BICESTERBUG

Submissions on proposed housing in NW Bicester

21/01630/OUT

22 June 2021

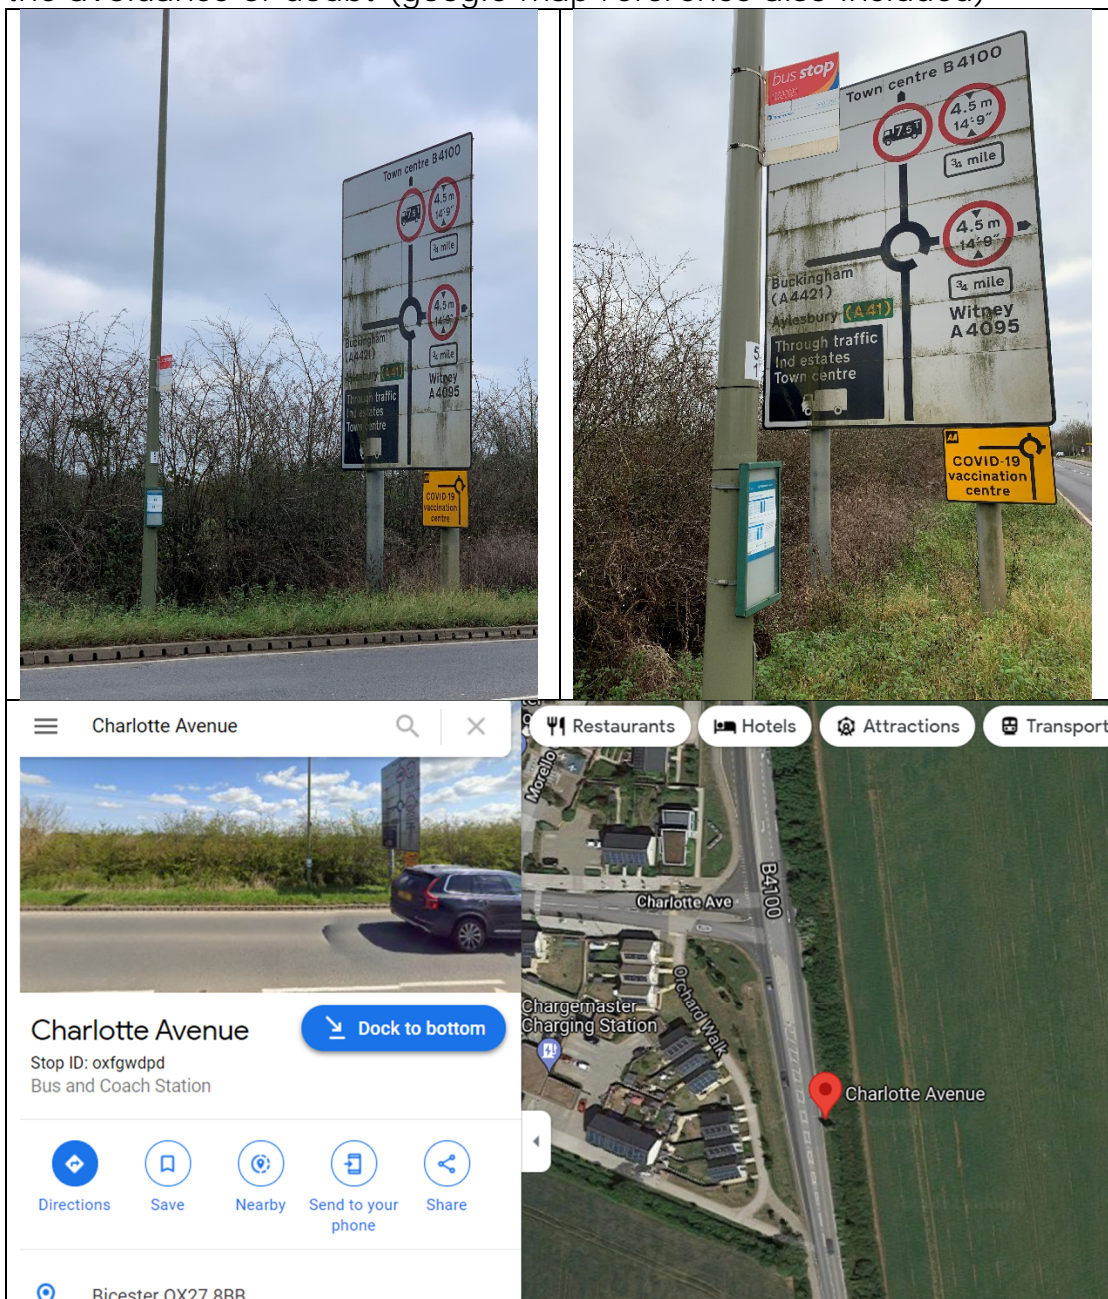
Section 5.7 is still incorrect in asserting that there is no bus stop on the eastern side of the B4100 the photograph below is included for the avoidance of doubt (google map reference also included)

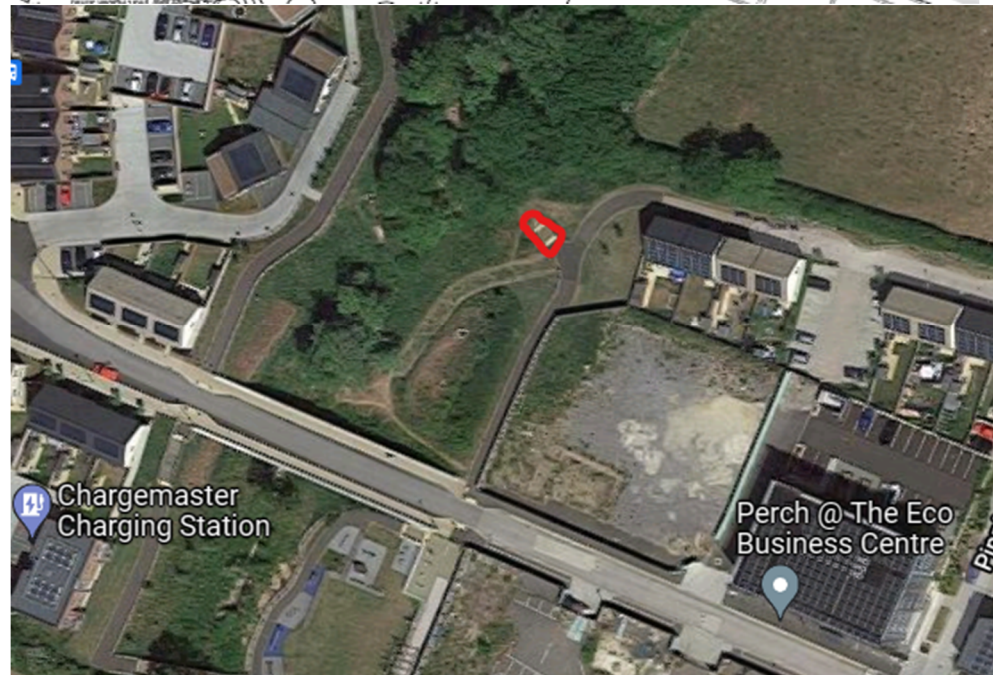
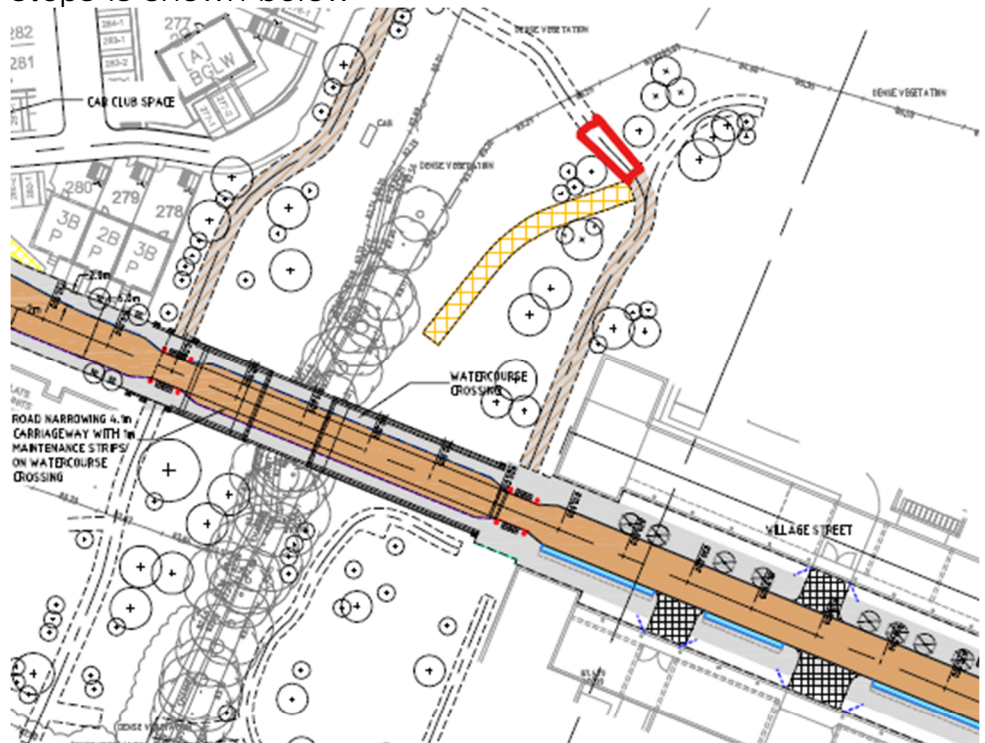
We welcome the conclusions that with the increased traffic flows the potential of the bridge to be a bottleneck and barrier to active travel (in turn driving up vehicle numbers still further) and that a solution needs to be found. We also note that in Item 4.2.8 it is asserted that the alternative to the spine road bridge via the foot bridge to the north is suitable for active travel. This is currently not the case due to the steps which make the route unsuitable for all users and would be inaccessible to bike users unable to dismount and carry a bicycle, such as the elderly, young and mobility impaired. The location of the steps is shown below
